BID TITLE: Fire Alarm System Replacement at Emmorton Elementary School

BID NUMBER: 10-DGH-012

Addendum #1

**EMMORTON ELEMENTARY SCHOOL
ADDENDUM NO. 1**

DRAWN:	JCW	DATE:	11/6/09	SKF-001
CHECKED:	RWB	SCALE:	AS NOTED

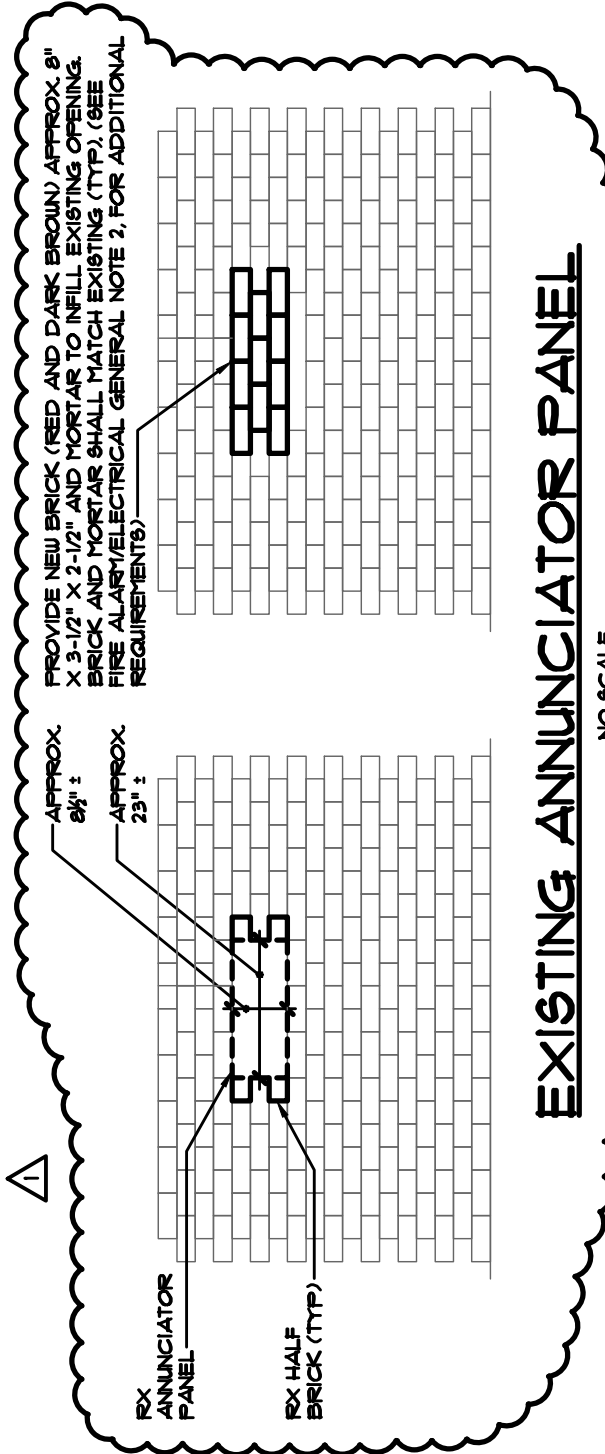
Clarification: **Contract Drawing FA-001**, see attached sketches (SKF -001, SKF-002, SKF-003, SKF-004) for additional clarifications.

DRAWN:	JCW	DATE:	11/6/09	SKF-002
CHECKED:	RWB	SCALE:	AS NOTED

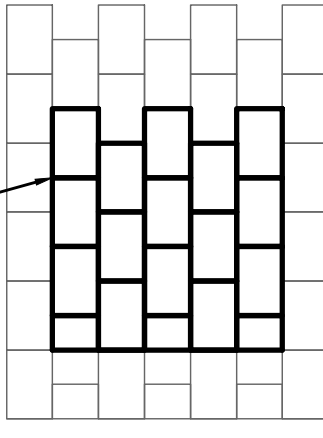
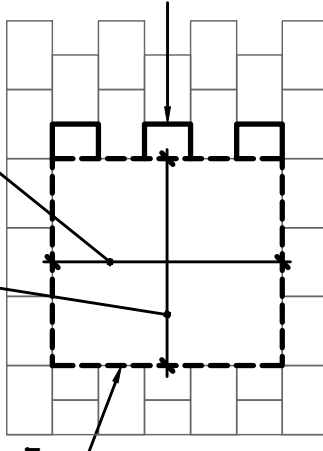
PROVIDE NEW BLOCK (PRIMED AND PAINTED) APPROX. 8" X 12" AND MORTAR TO INFILL EXISTING OPENING. BLOCK AND MORTAR SHALL MATCH EXISTING (TYP). (SEE FIRE ALARM/ELECTRICAL GENERAL NOTE 2, FOR ADDITIONAL REQUIREMENTS)

RX FIRE ALARM CONTROL PANEL

RX HALF BLOCK (TYP)

DRAWN: JCW	DATE: 11/6/09	SKF-003
CHECKED: RWB	SCALE: 1/8"=1'-0"

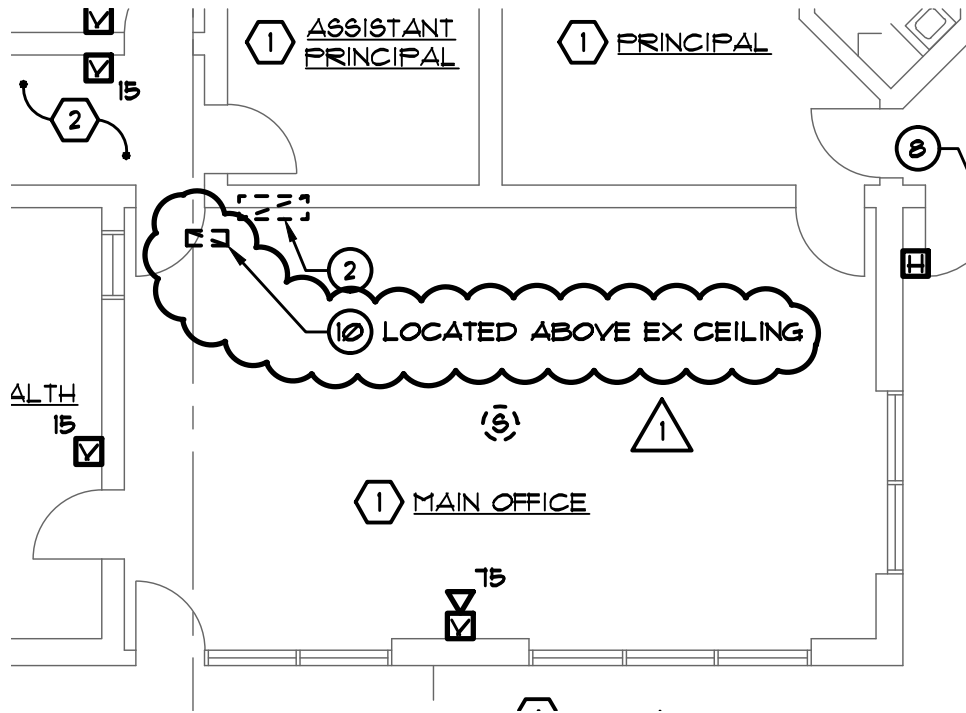
(10) RX SURFACE MOUNTED FIRE ALARM TELEPHONE DIALER AND TURN OVER TO HCPS FACILITIES DEPARTMENT. REMOVE ALL ASSOCIATED EX FIRE ALARM WIRING, RX 120 VOLT BRANCH CIRCUIT WIRING AND ALL ASSOCIATED EXPOSED CONDUIT BACK TO FIRE ALARM CONTROL PANEL.

FIRE ALARM RISER DIAGRAM

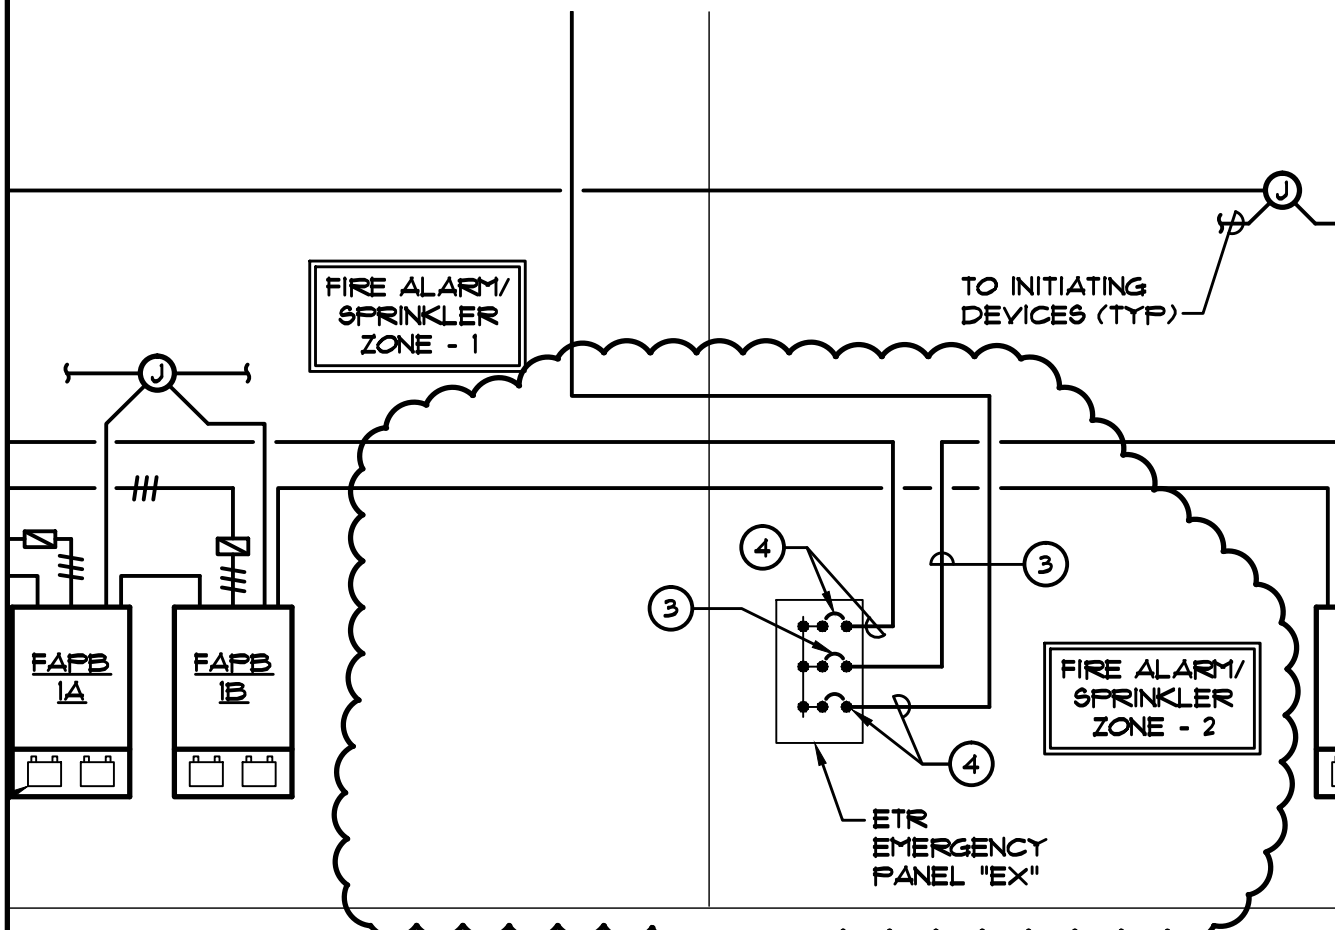
- ③ EXTEND 2#12 & 1#12 GRD-3/4" C AND PROVIDE 1P-20A CIRCUIT BREAKER WITH LOCK CLIP TO MATCH EX PANEL MANUFACTURER
- ④ EXTEND 2#8 & 1#10 GRD-1" C AND PROVIDE 1P-20A CIRCUIT BREAKER WITH LOCK CLIP TO MATCH EX PANEL MANUFACTURER
